**STAFF REPORT
FOR THE PLANNING COMMISSION**

FILE NUMBER: DR-18-08

REQUEST: Site Design Review to construct a new commercial building at 2180 8th Court

1
C1.0 PROPOSED SITE PLAN
SCALE: 1" = 20'

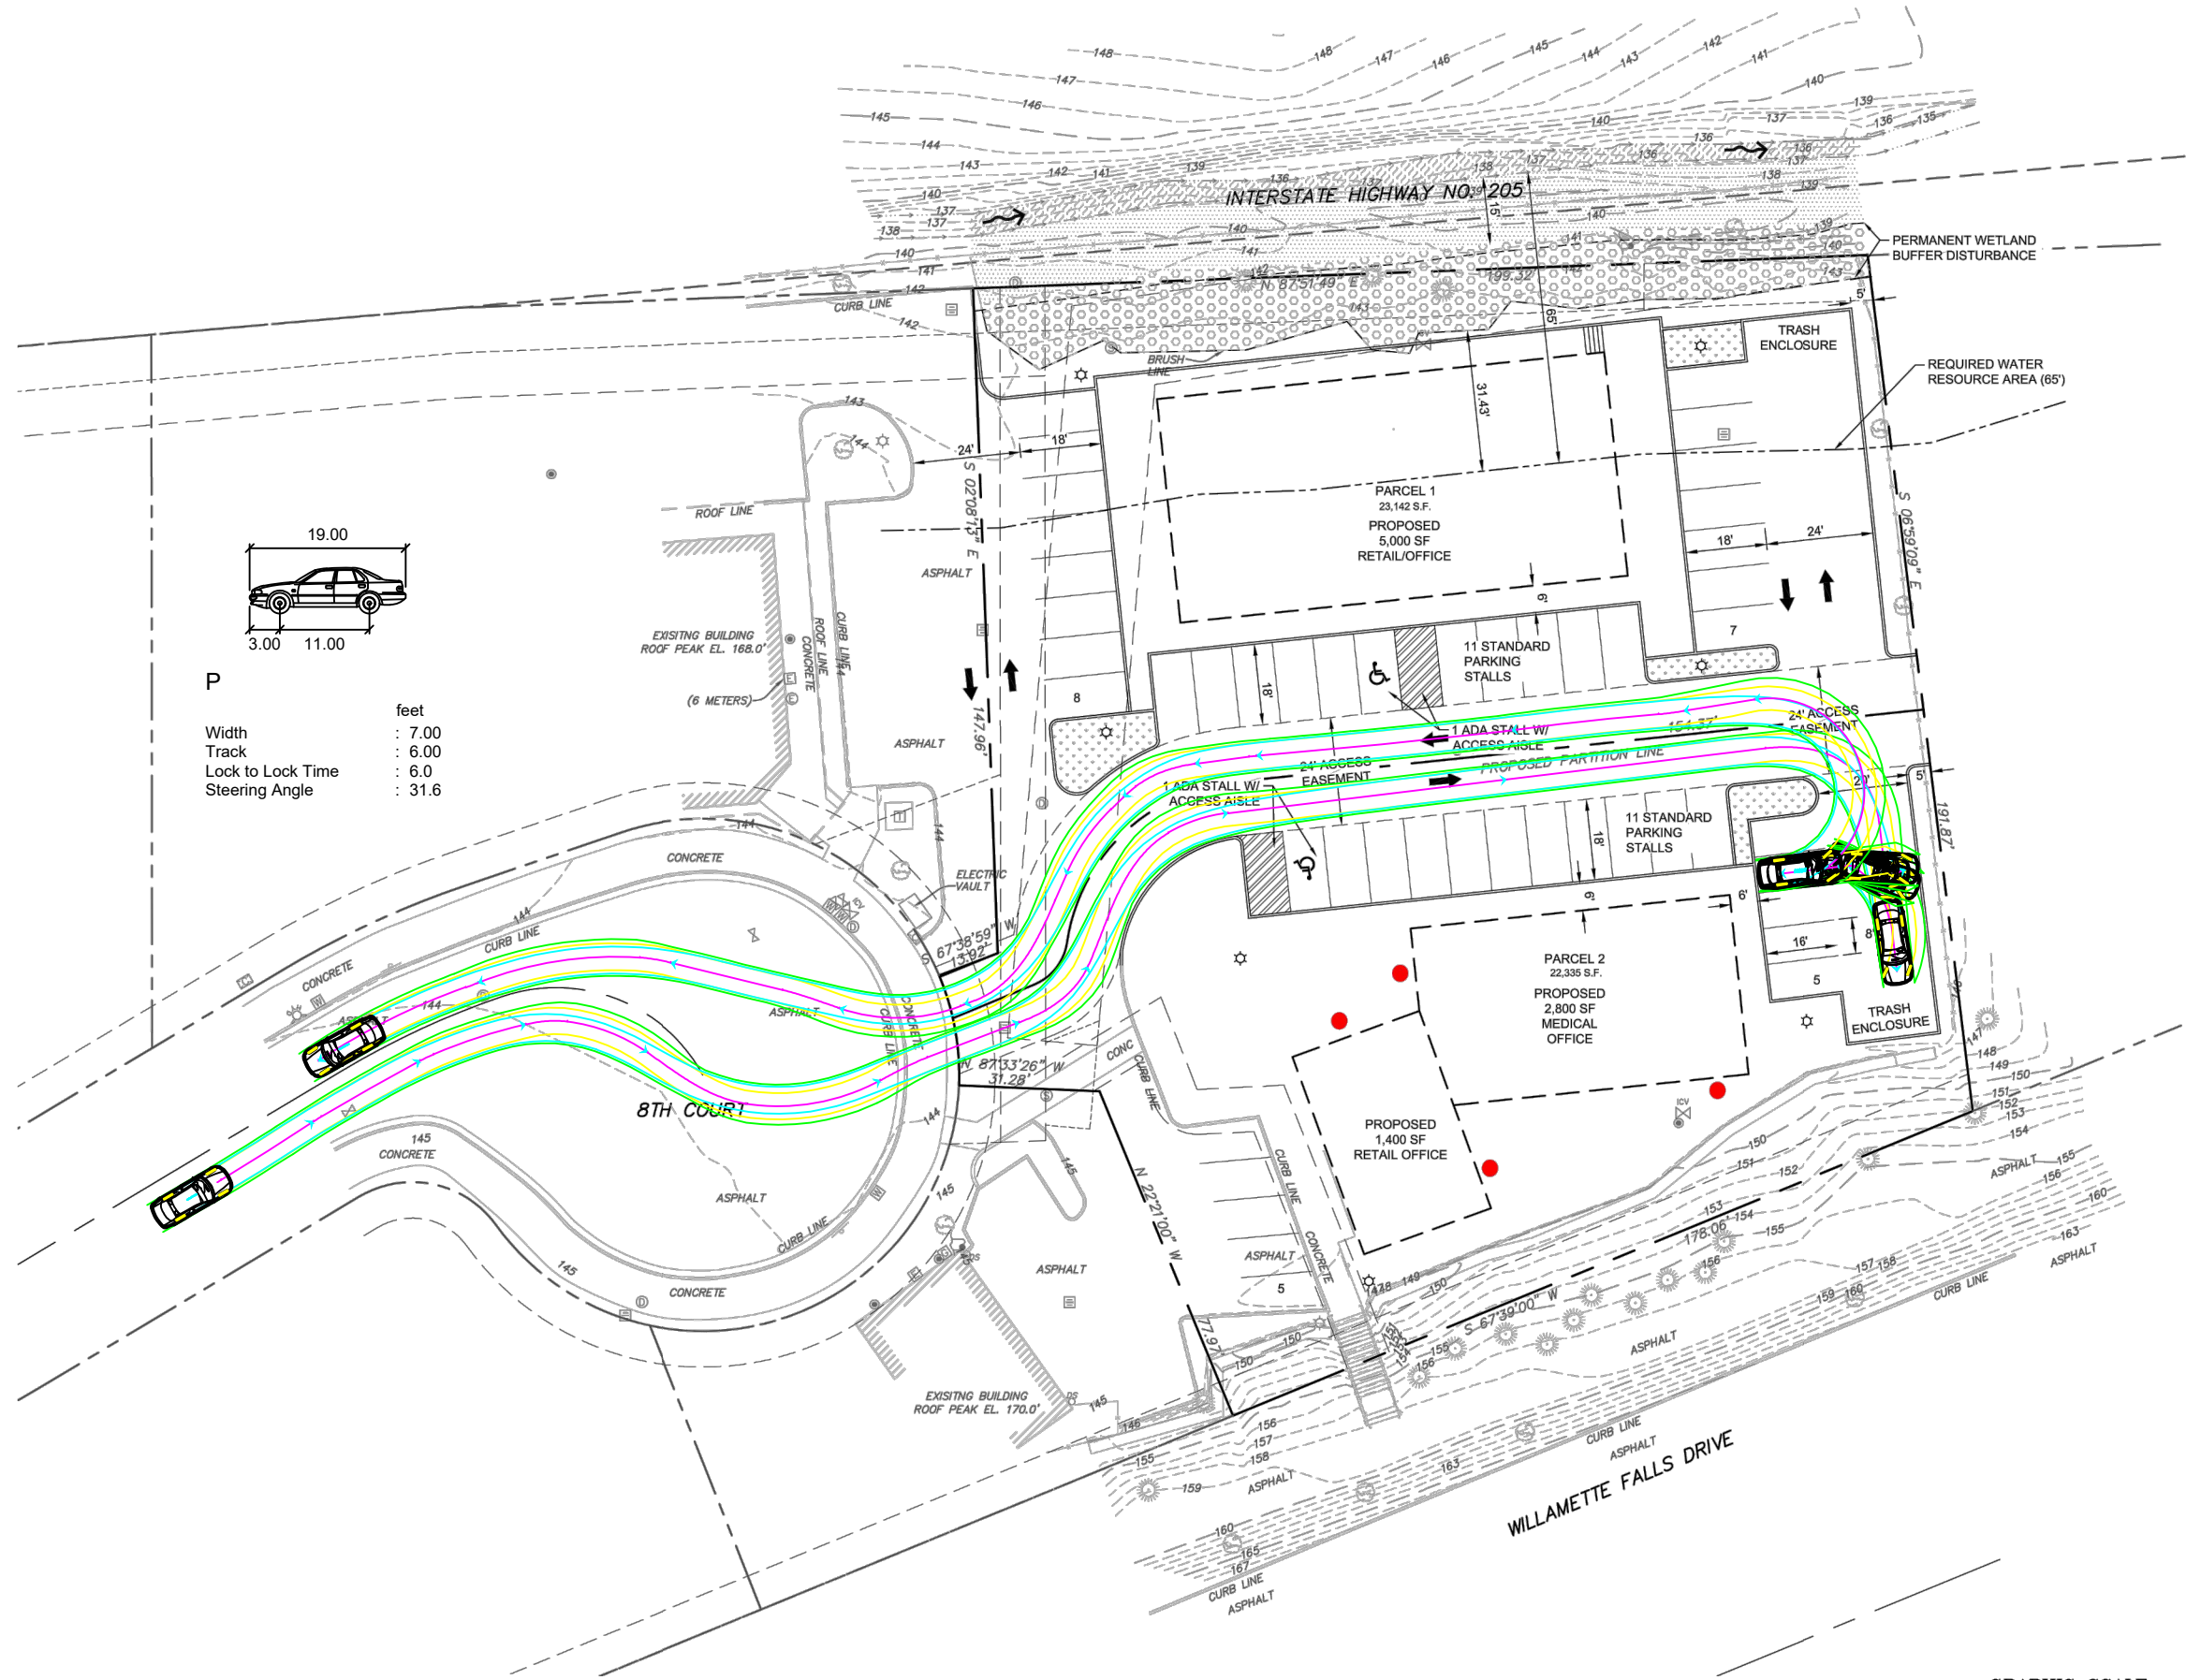
2. **DEAD END ROADS AND TURNAROUNDS:** Dead end fire apparatus access roads in excess of 150 feet in length shall be provided with an approved turnaround. Diagrams can be found in the corresponding guide that is located at <http://www.tvfr.com/DocumentCenter/View/1296>. (OFC 503.2.5 & D103.1) **The provided site plan does not appear to meet the above requirements. Please provide an approved turnaround.**

- DEAD END ROADS AND TURNAROUNDS:** Dead end fire apparatus access roads in excess of 150 feet in length shall be provided with an approved turnaround. Diagrams can be found in the corresponding guide that is located at <http://www.tvfr.com/DocumentCenter/View/1296>. (OFC 503.2.5 & D103.1) **Current plan meets. The revised site plan dated 12/19/18 meets the above requirements.**
